1112 W. ANNIE ST.

SP-2020-0093DS

Environmental Review Specialist Senior

Development Services Department

Proposed Site Plan Enlargement

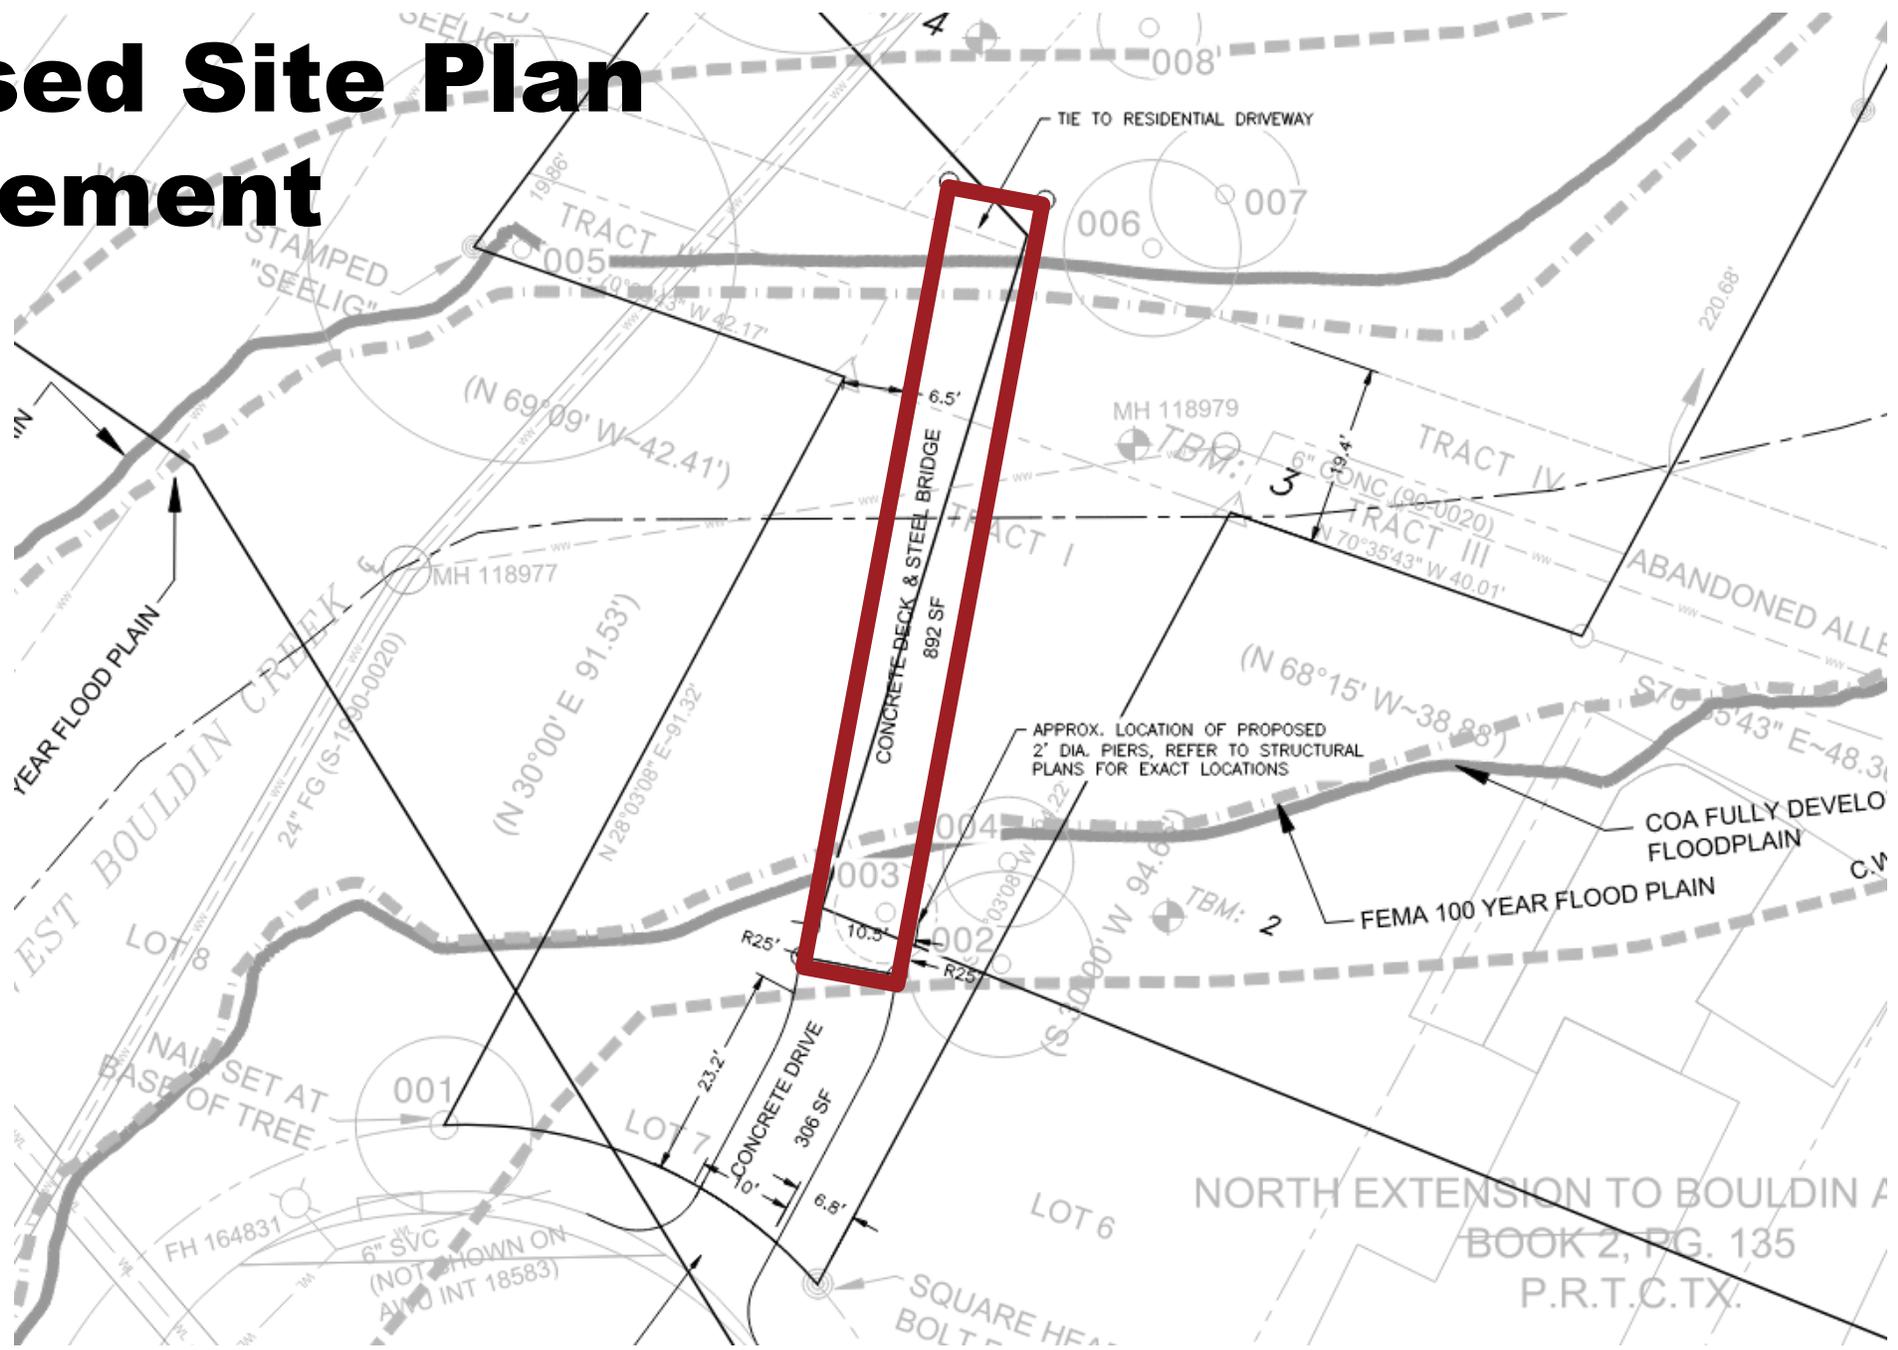
VARIANCE REQUEST

To allow development inside the Critical Water Quality Zone (LDC 25-8-261)

- To allow the drive to cross the critical water quality zone.

Figure 2

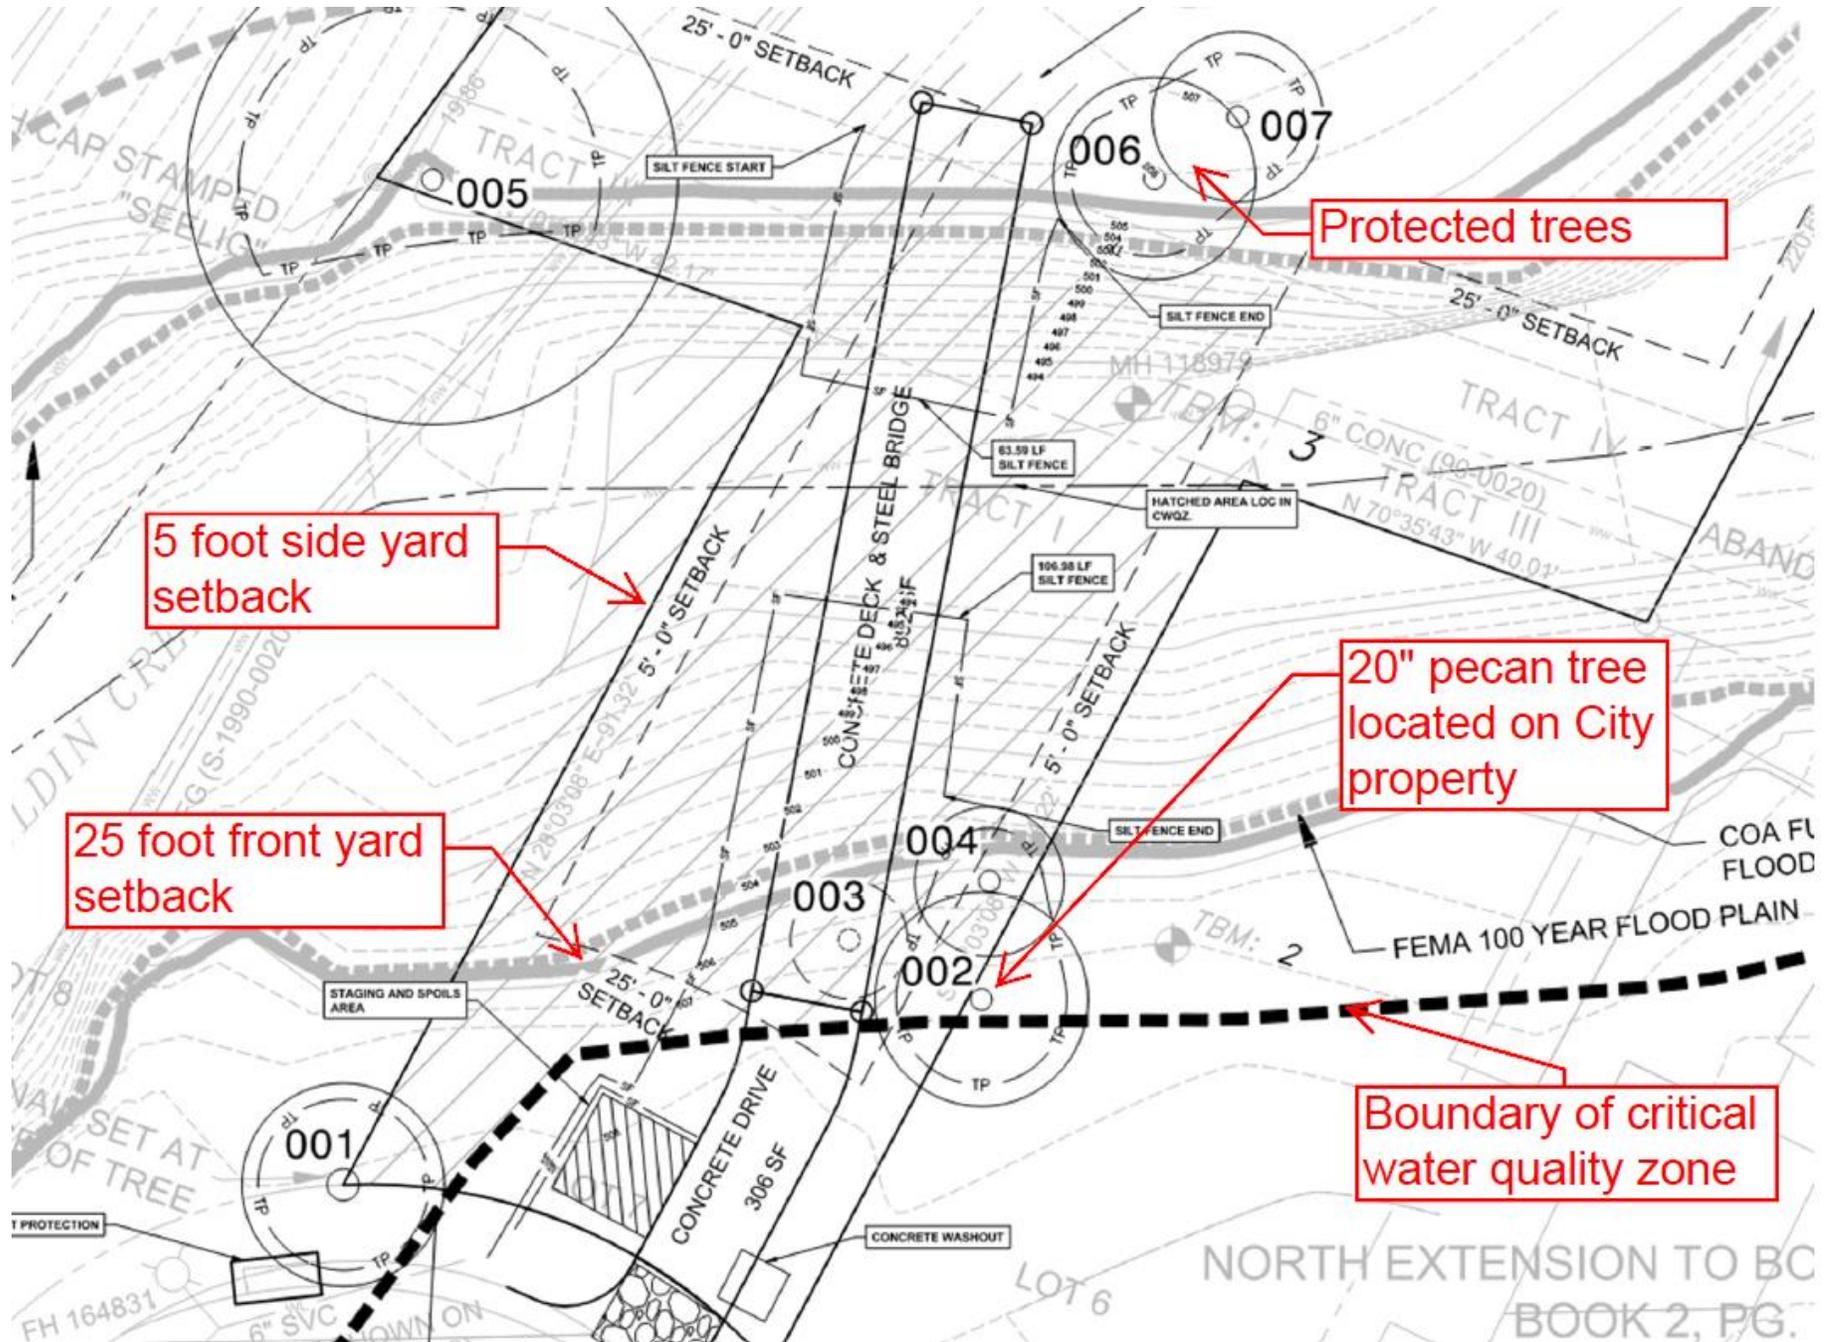
- 2a: The variance: Is not necessitated by the scale, layout, construction method, or other design decision made by the applicant, unless the design decision provides greater overall environmental protection than is achievable without the variance:

- Staff determination: Yes.

The proposed bridge over West Bouldin Creek is the only access point that the owner has from City ROW to their buildable lot. The proposed bridge has been designed to take the most direct path across the creek while also minimizing, to the maximum extent feasible, disturbance to the critical water quality zone and avoiding disturbance to the critical root zone of tree #002, which is an existing 20" pecan tree that is located on adjacent City property (Figure 2 next slide). Furthermore, the design also avoids the removal of trees #004, 006 and 007, all of which are Pecan species located on the project property (Figure 2 next slide). Moreover, the proposed location of the bridge also adheres to the minimum 5 foot side yard & 25 foot front yard setback requirements in accordance with LDC 25-2-513 & 492 (Figure 2 next slide). Therefore, the variance is not necessitated by the scale, layout, construction method, or other design decision made by the applicant.

Figure 3

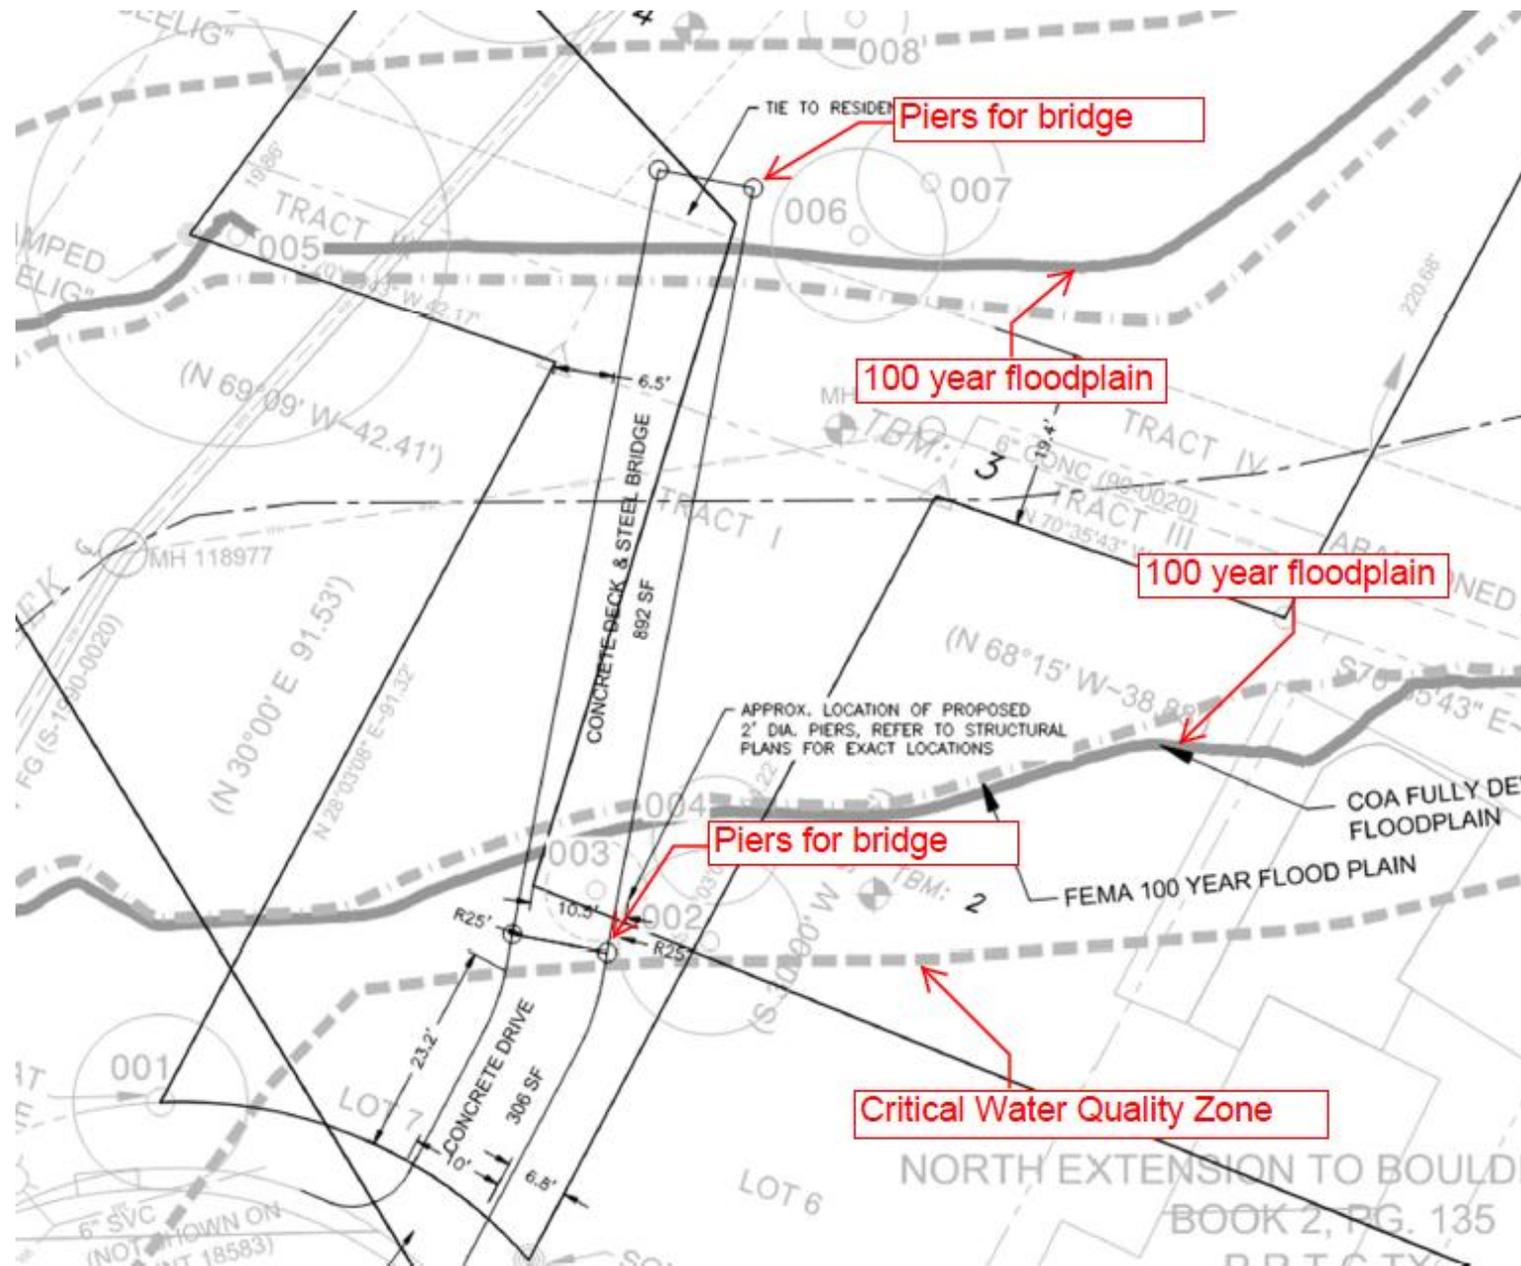
- 2b: The variance is the minimum deviation from code requirement necessary to allow a reasonable use of the property.
 - Staff determination: Yes.

The proposed bridge has been designed to span the 100 year floodplain (Figure 3 next slide). It has also been designed to remove the least amount of protected sized trees located on site and also avoids disturbance of the critical root zone of the larger 20” pecan tree that is located on adjacent City property. Therefore, staff agrees that the design and location of the proposed bridge is the minimum deviation from code requirement necessary to allow a reasonable use of the property.

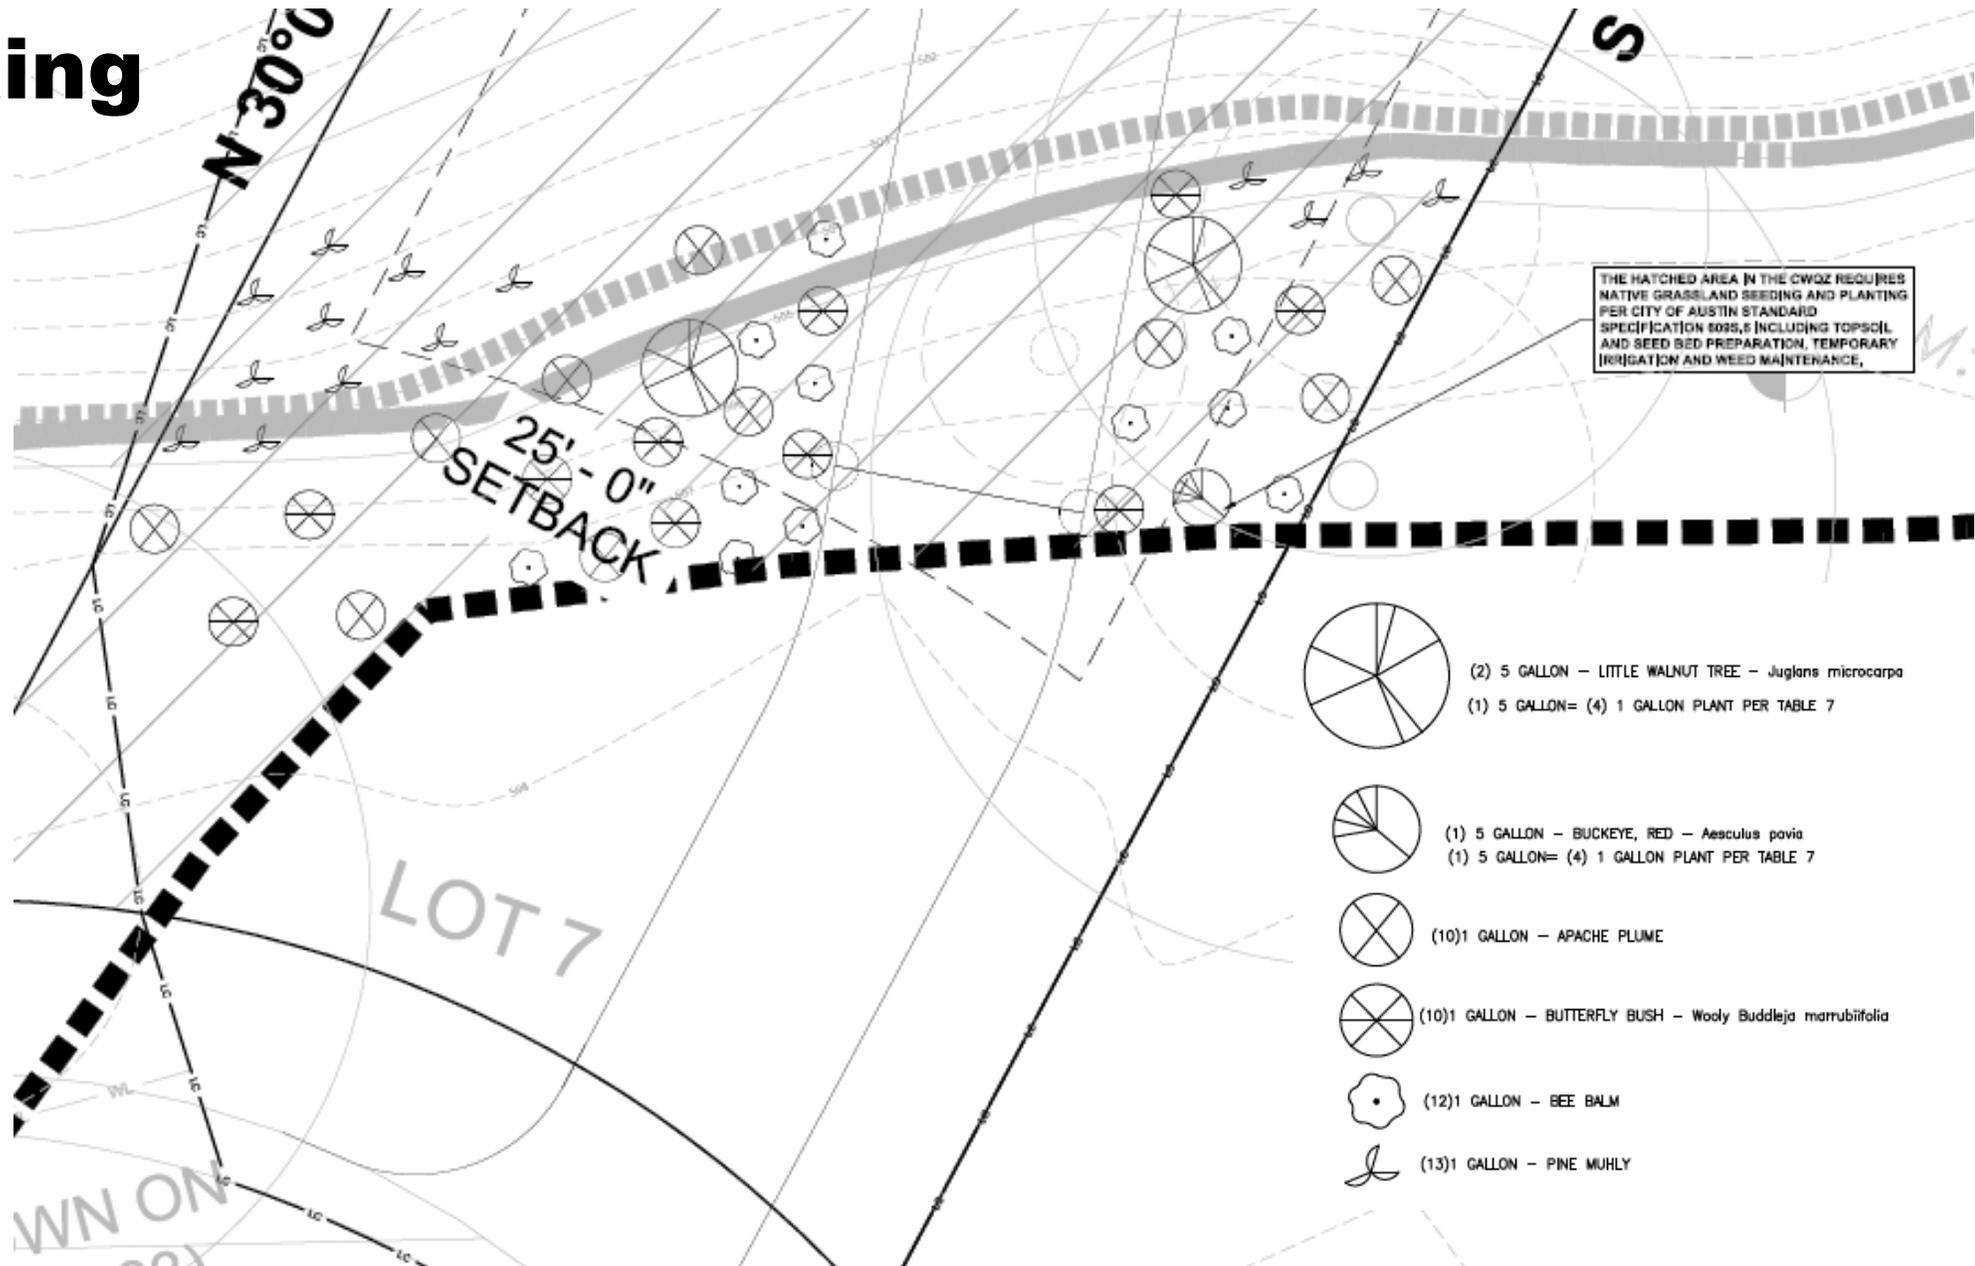
- 3: Development with the variance will result in water quality that is at least equal to the water quality achievable without the variance:
 - Staff determination: Yes
As this proposed bridge has been designed to span the 100 year floodplain there will not be any obstructions within the waterway. Due to the increase in impervious cover being less than 8,000 square feet the project does not require water quality treatment in accordance with City code. However, City standard specification 609S – Native Seeding and Planting is required within the limits of construction. Therefore, development with the variance will result in water quality that is at least equal to the water quality achievable without the variance.
